APPLICATION NO.	FILING DATE	FIRST NAMED INVENTOR	ATTORNEY DOCKET NO.	CONFIRMATION NO.
09/942,001	08/29/2001	Otto Lodewijk Steinbusch	NL 000477	9027

Office Action Summary

DETAILED ACTION

FIG. 2

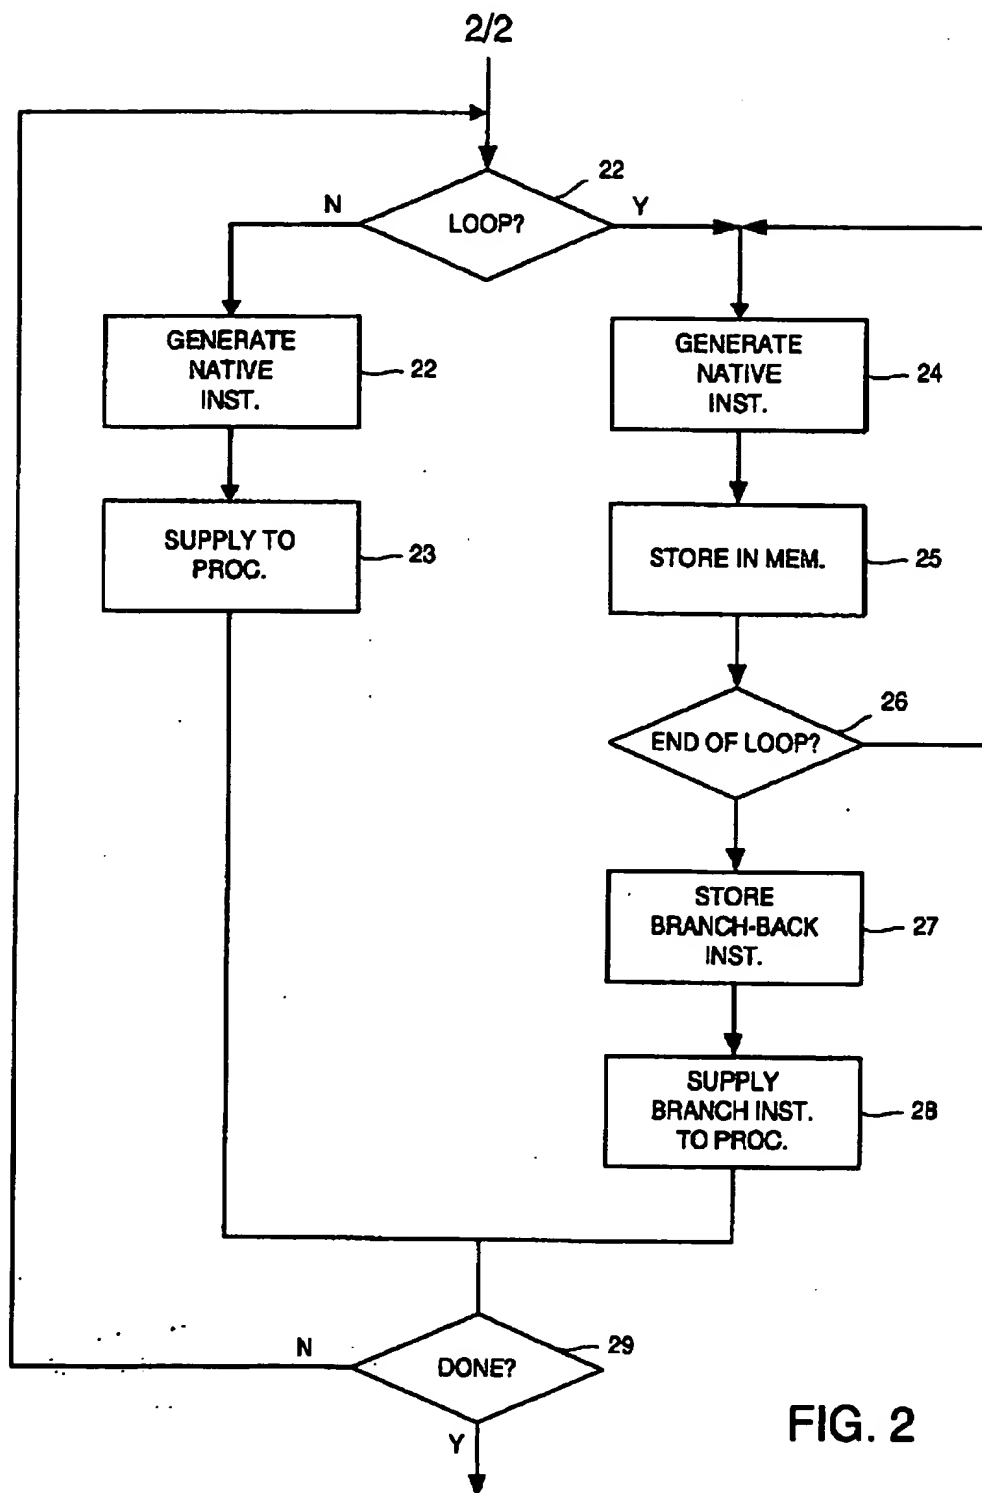
3. Examiner acknowledges the receipt of Replacement Sheets for FIG. 1 and FIG. 2. The prior objection to the drawings is hereby withdrawn.
